Town Planning Evidence Statement

*Amendment C433ggee (Pakington Street, Geelong
West) to the Greater Geelong Planning Scheme*

*Instructed by Harwood Andrews for City of
Greater Geelong*

REPORT FOR	Planning Panels Victoria
AMENDMENT NUMBER	C433ggee
RESPONSIBLE AUTHORITY	Greater Geelong City Council
AUTHOR	Statement prepared by John Glossop, Director Glossop Town Planning Pty Ltd Date: 9 February 2026

Figure 3. Laneway interface (pedestrian)

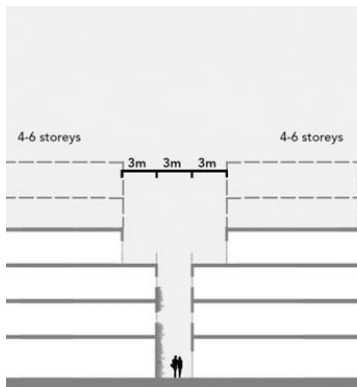
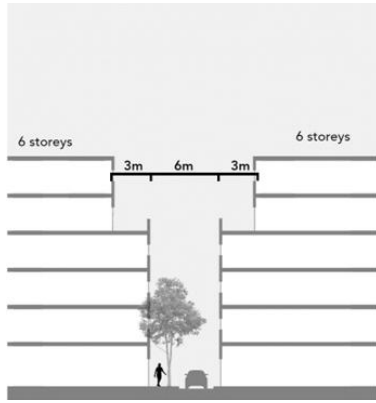
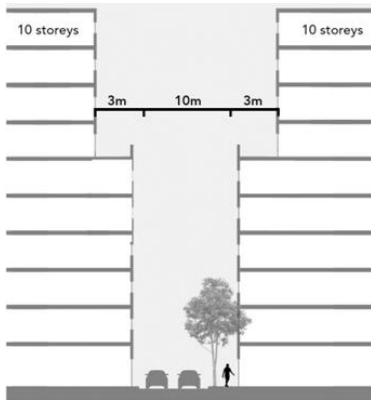
- 101 Map 1 of DDO56 includes indicative locations for 10m wide laneways, 6m wide laneways and 3m wide pedestrian links. It also includes sections indicating appropriate interfaces to pedestrian (Figure 3,) service (Figure 4) and new street (Figure 5) laneways. Firstly, the language between Map 1 and Figures 3-5 should be consistent for clarity. Secondly, there is no related requirement to provide these links although there is a requirement listed under Active Frontages to: Ensure laneways and pedestrian links are publicly accessible, safe (comply with *Crime Prevention Through Environmental Design* guidelines), receive adequate access to sunlight and are open to the sky.

- The canopy trees shown in the interface requirements should be deleted from the section drawings as in many cases landscaping is not a reasonable expectation. I also recommend that the section drawing requirements be simplified to reflect an unadorned envelope.

- 119 The naming of pedestrian / service / new streets should be consistent between Map 1 and Figures 3-5.
- 120 In Clause 11.03-6L-06, I recommend the following *change*:

Figure 6. Preferred side separation for buildings up to 8 storeys built to boundary

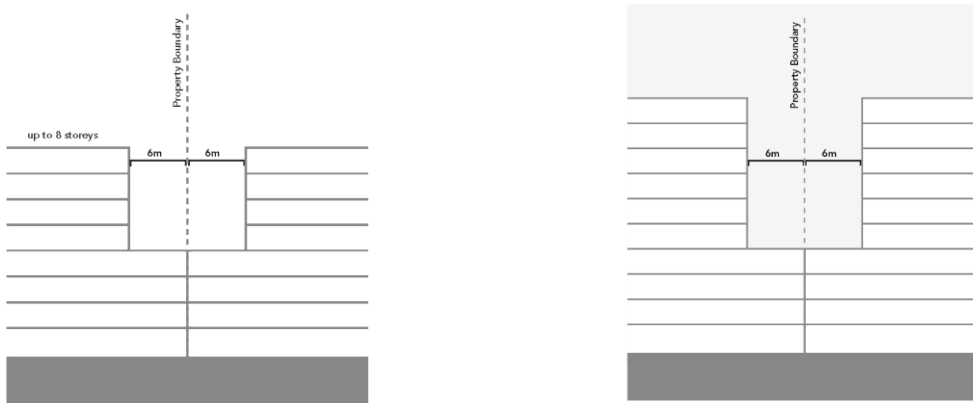
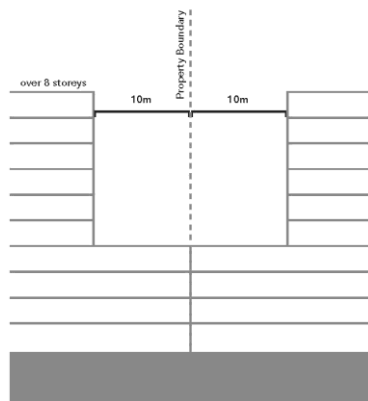
[Editing Note: Diagram above left replaced with diagram above right showing additional two more levels and removing the text “up to 10 storeys.”]

[Editing Note: Diagram deleted]

Figure 8. Open space interface

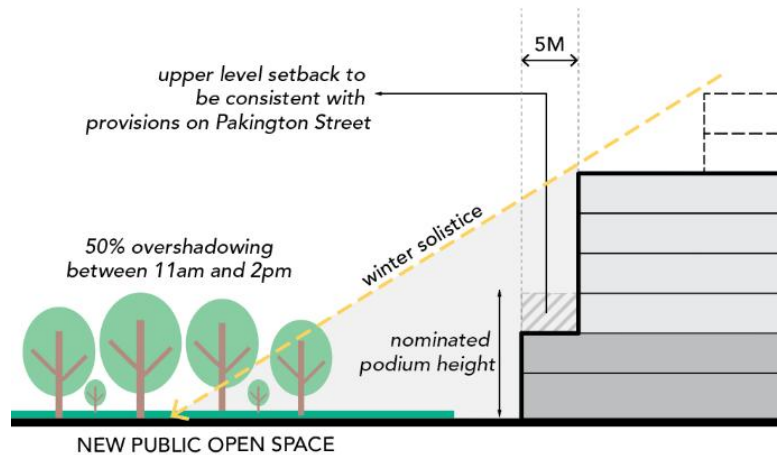
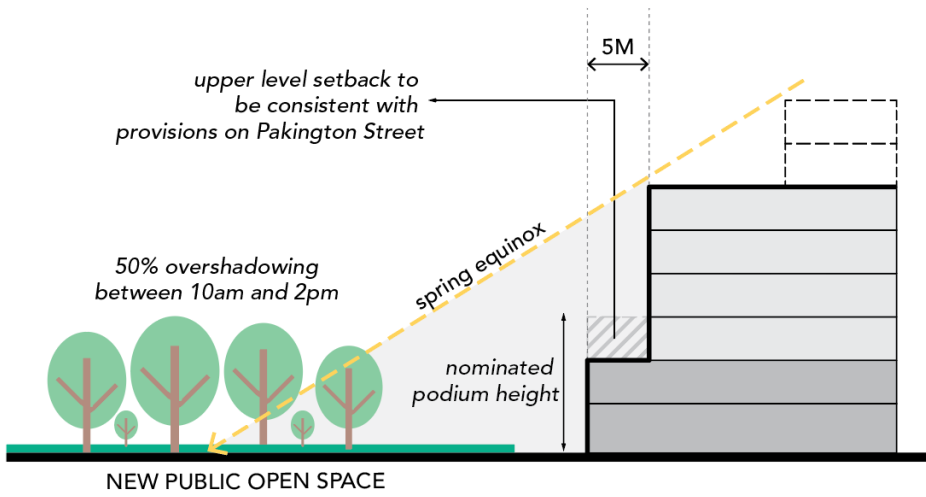
[Editing Note: Delete diagram above and replace with diagram below showing label spring equinox and 10am-2pm.]
